ADDENDUM NO. 2

PROJECT: NW Connell and NW Garibaldi Street Improvements, No. 10485

DATE: June 27, 2013

This addendum to the contract documents is issued to clarify, correct, and supplement the drawings and contract documents issued as "NW Connell and NW Garibaldi Street Improvements", bid closing date July 2, 2013.

SHEET NO.
C-104

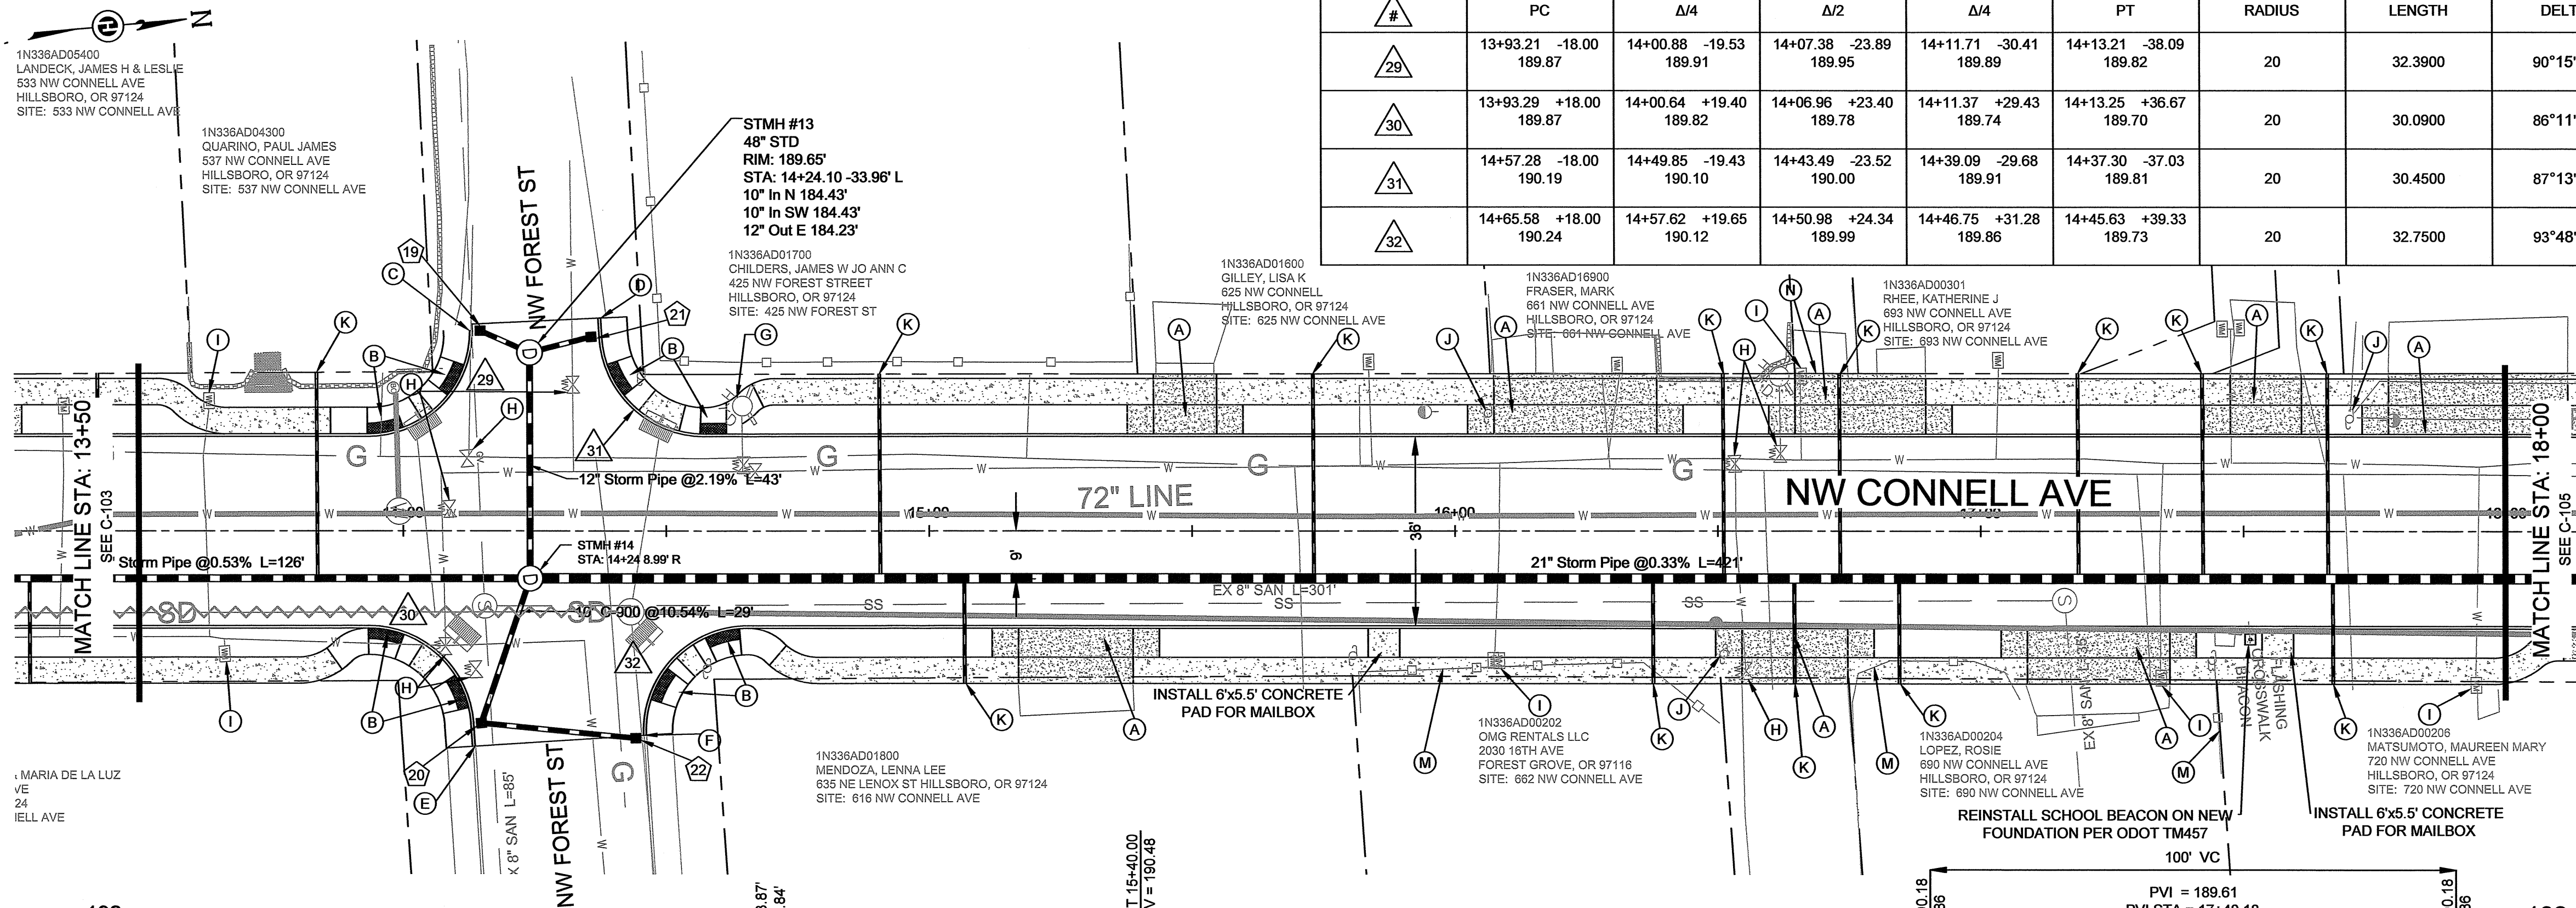
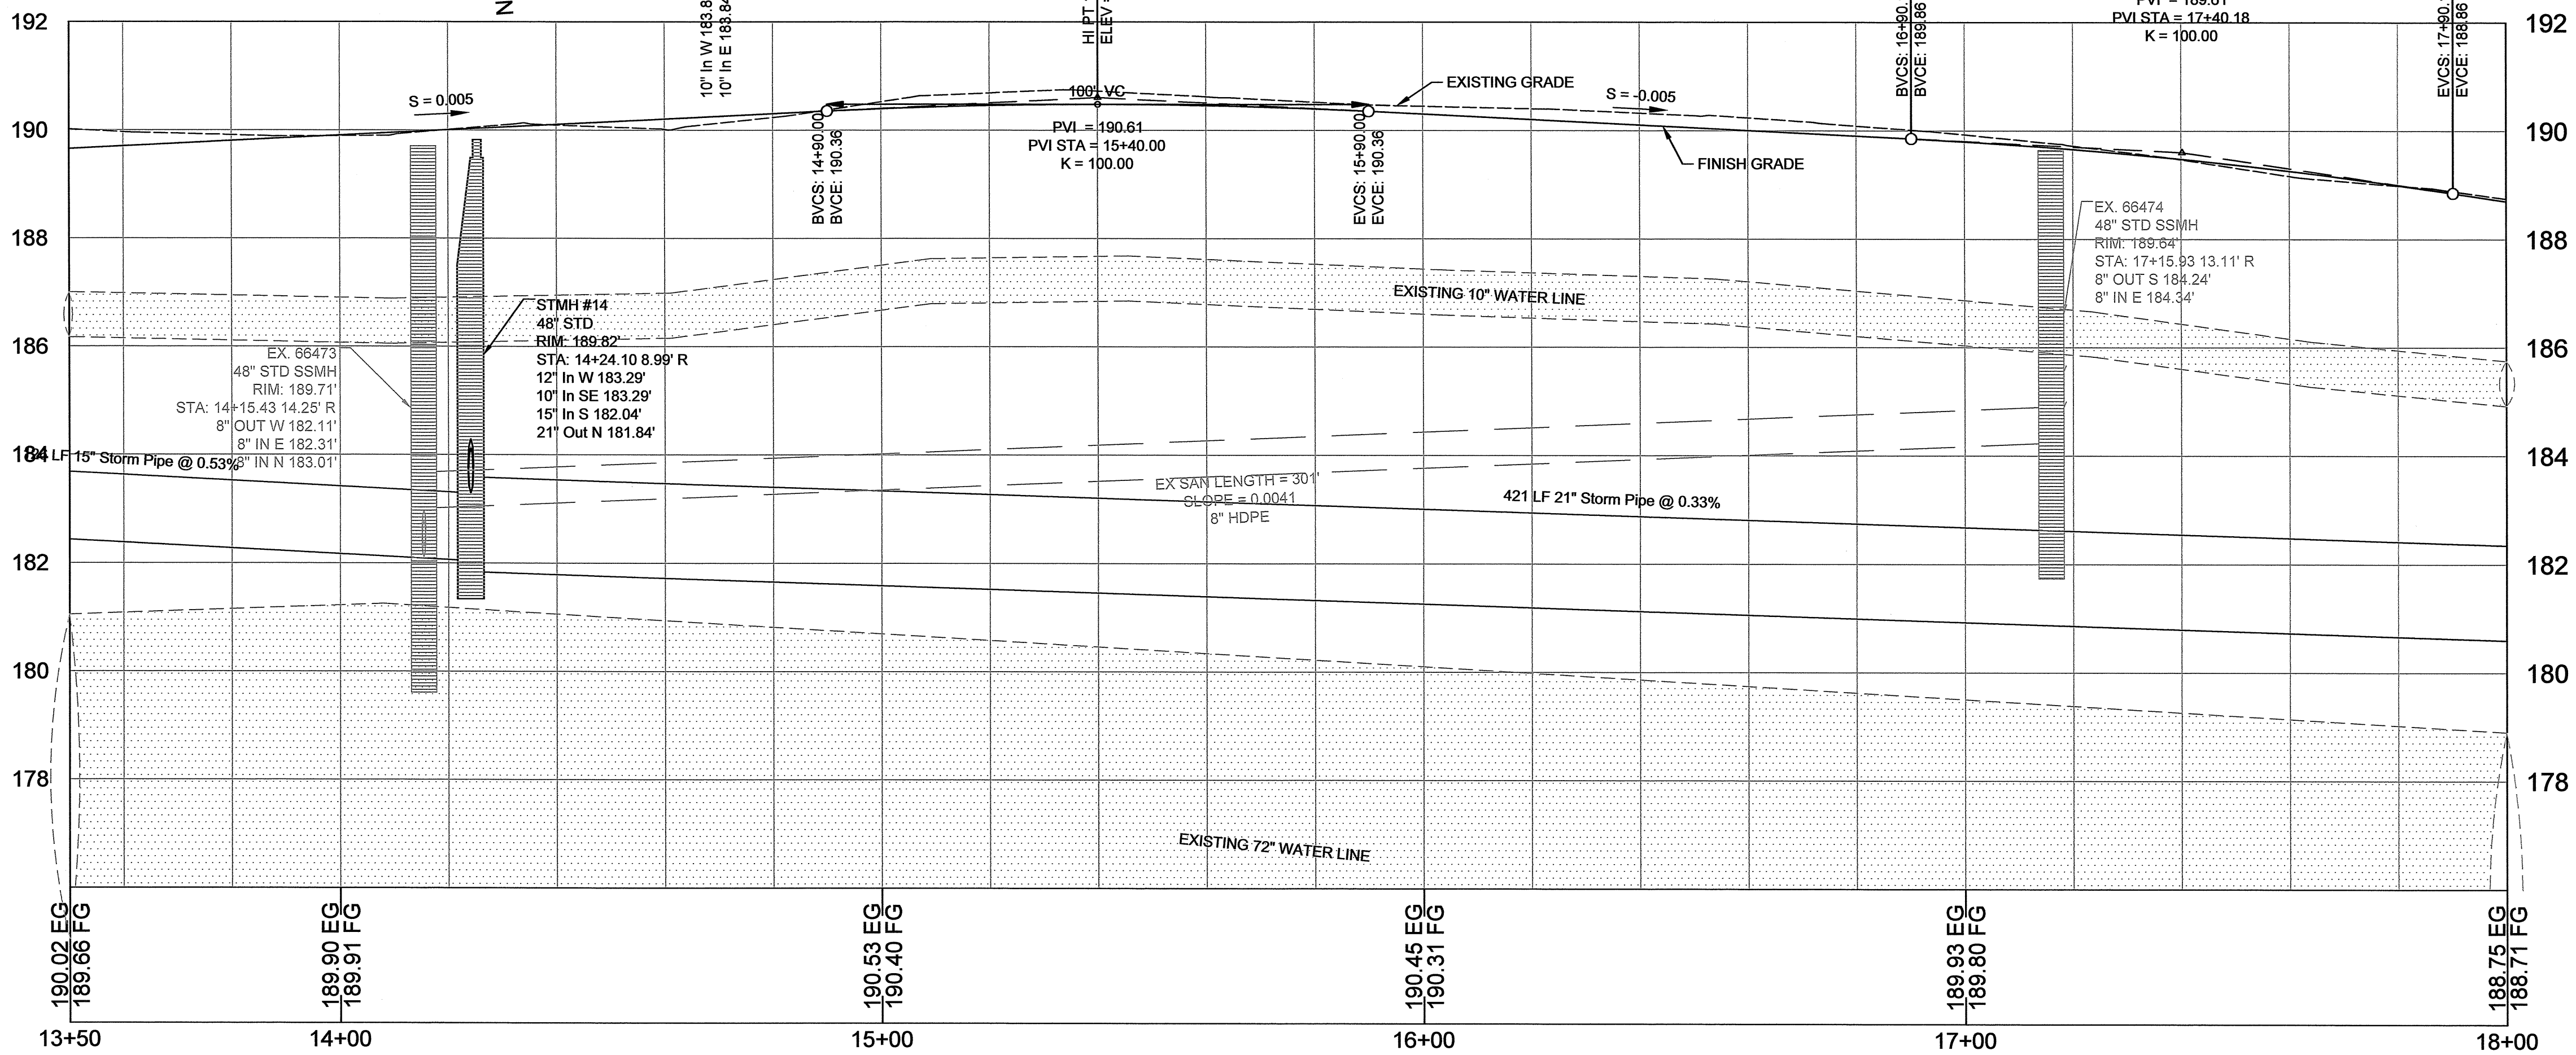
Page C-104 (18 of 32)

1. All Catch Basin Runs should be 10" C-900 pipe.
2. Some of the notes for STMH #13 are missing. Add the following notes for STMH#13:

STMH #13
STA 14+24 34' L
48" STD MANHOLE
RIM = 189.65
IE IN = 184.43 10" N & SW
IE OUT = 184.23 12" E

SHEET NO.
C-106

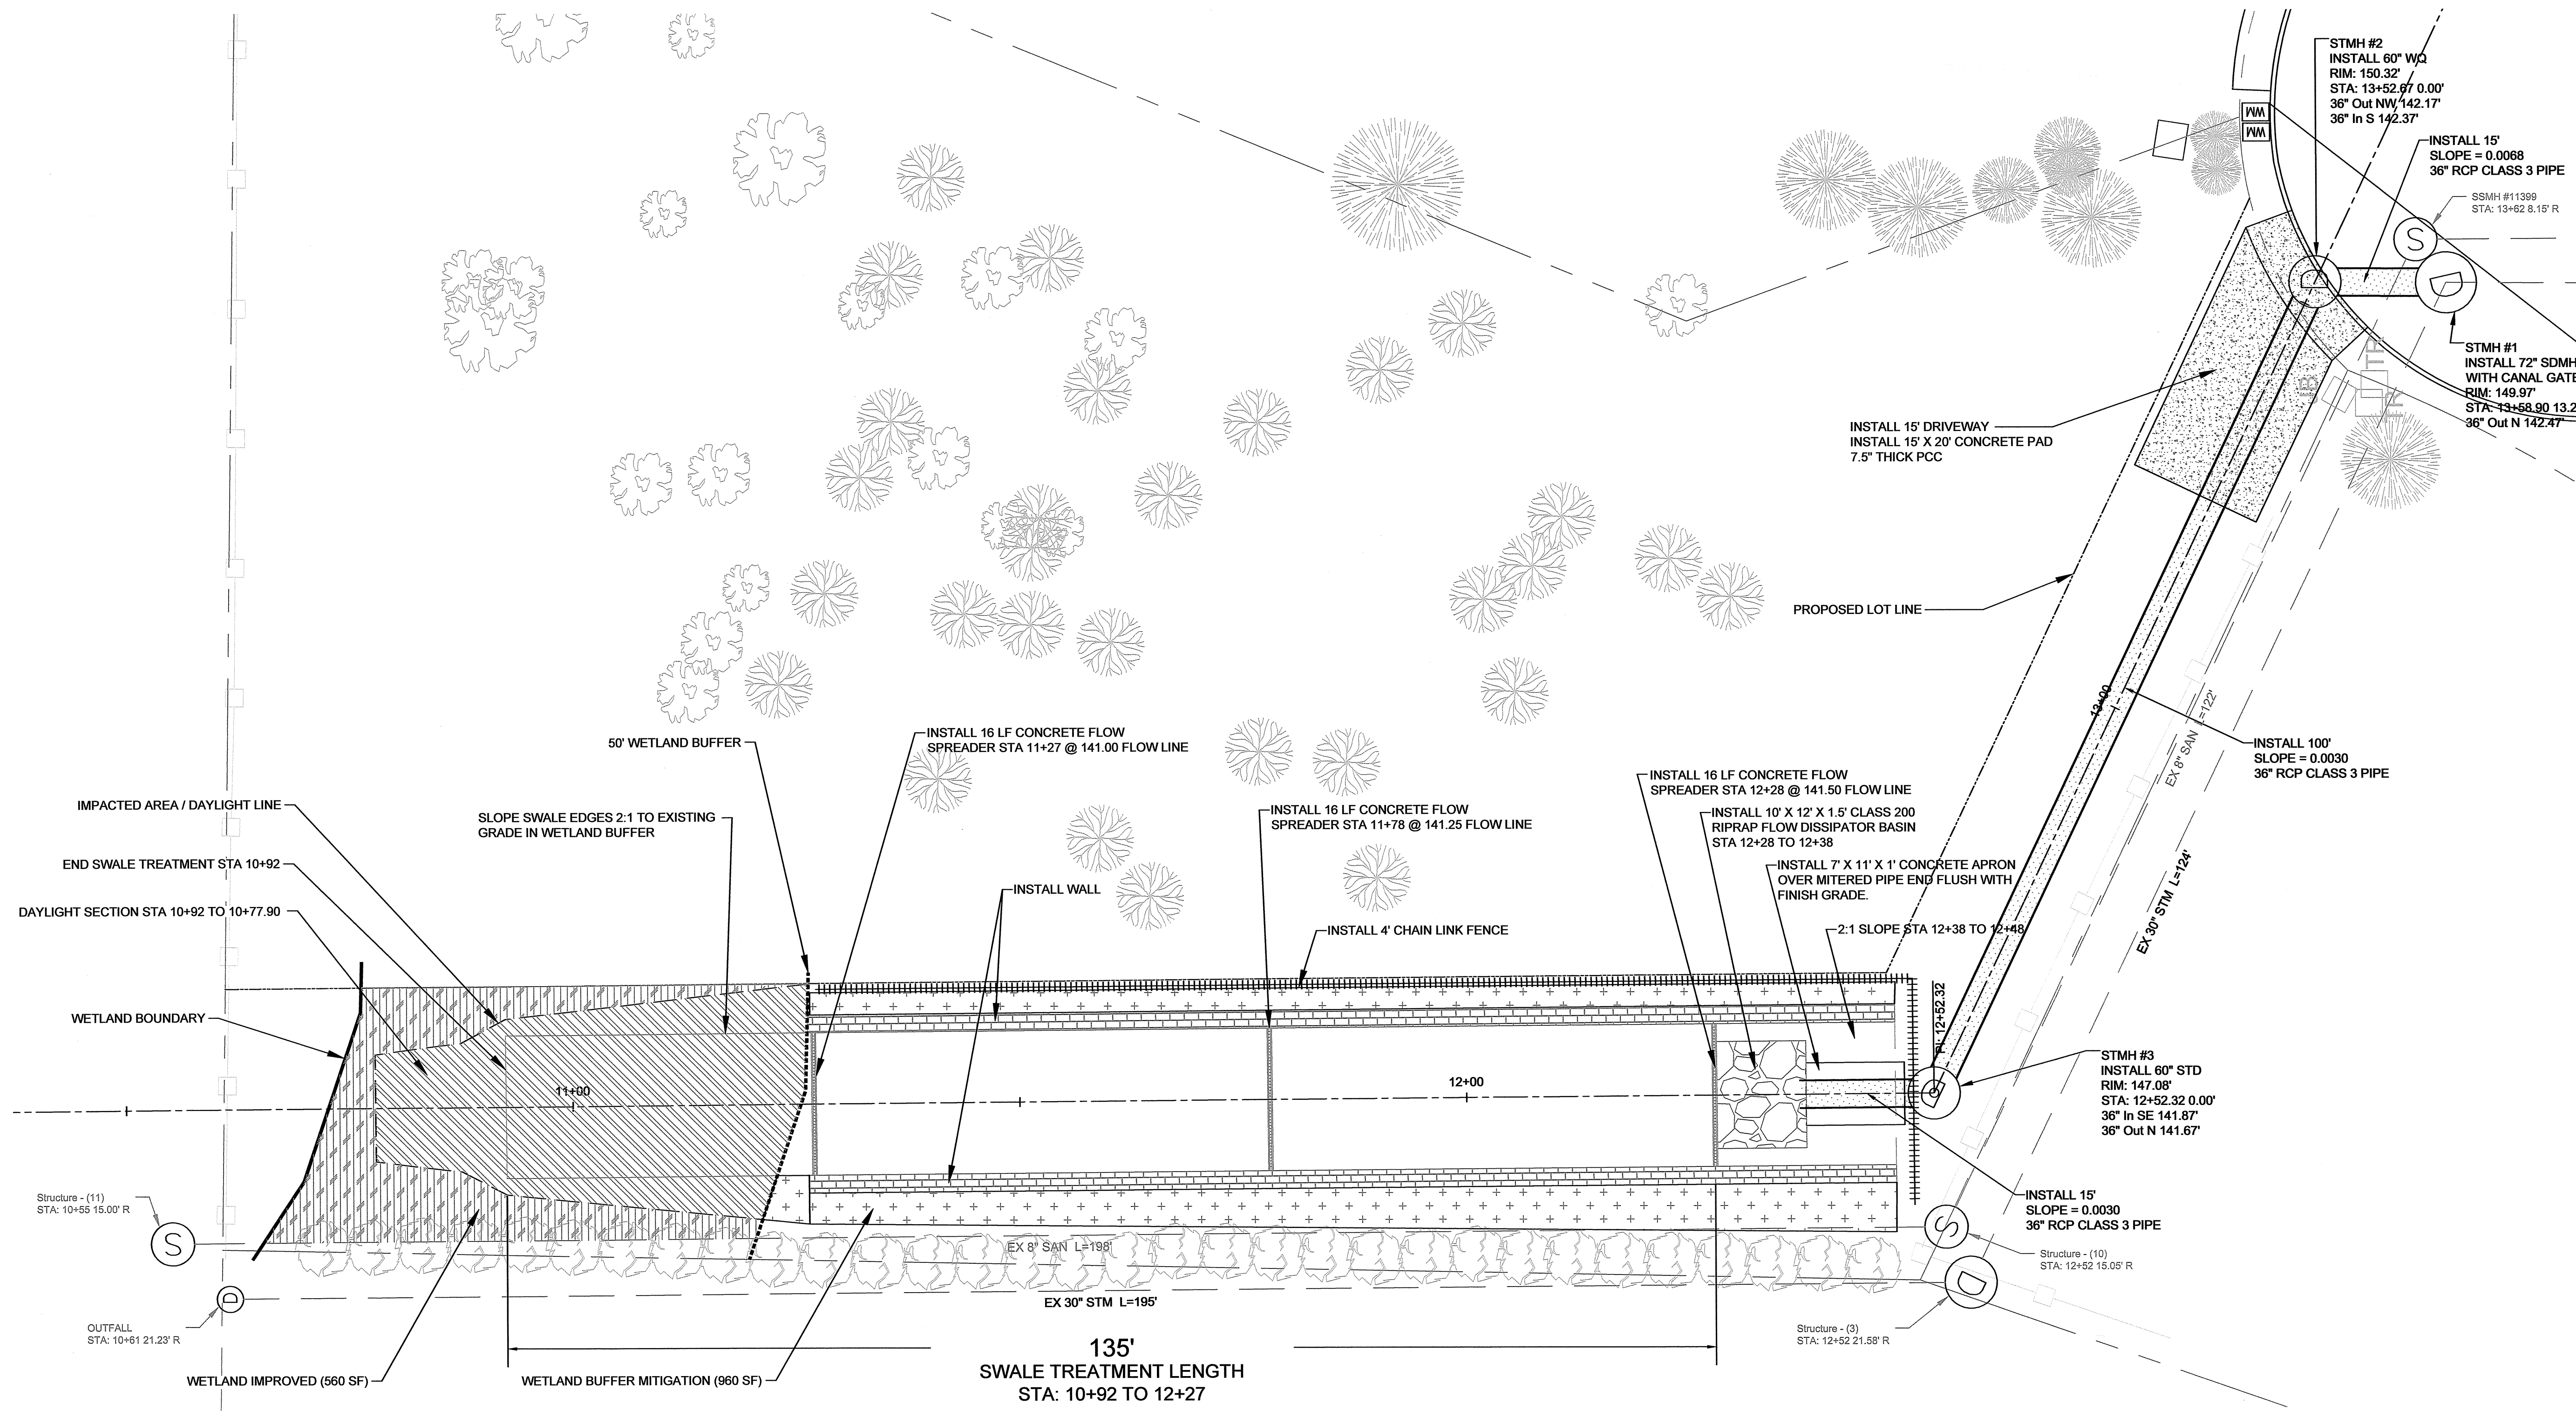
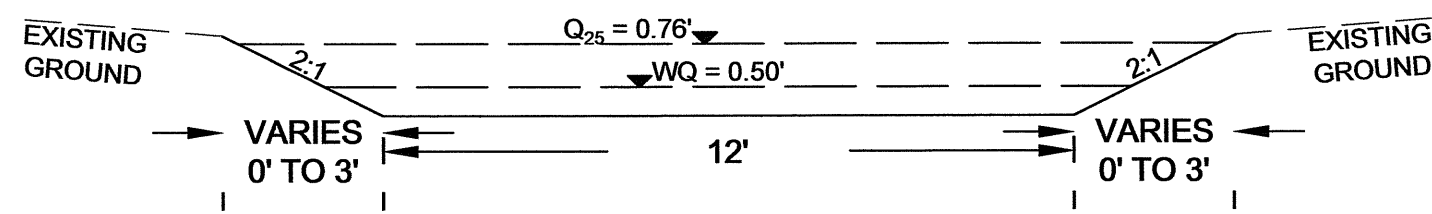
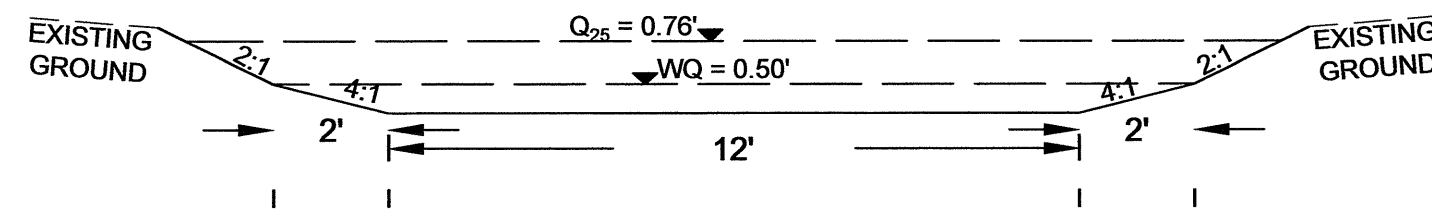
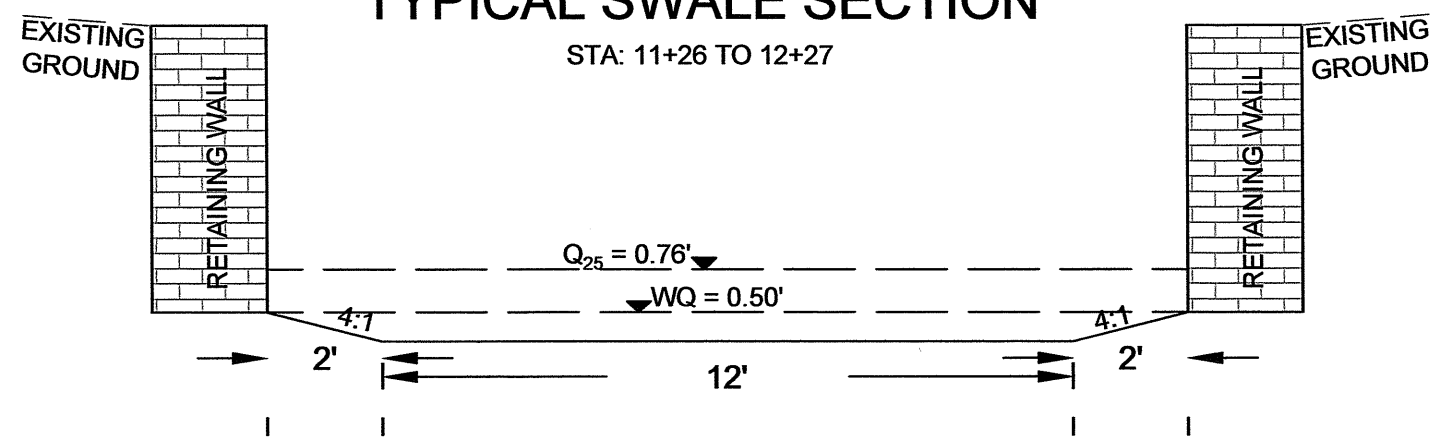
Pages C-106 and C-106A (21&22 of 32)

1. Change all 36" pipe to 36" Class 3 Concrete pipe.
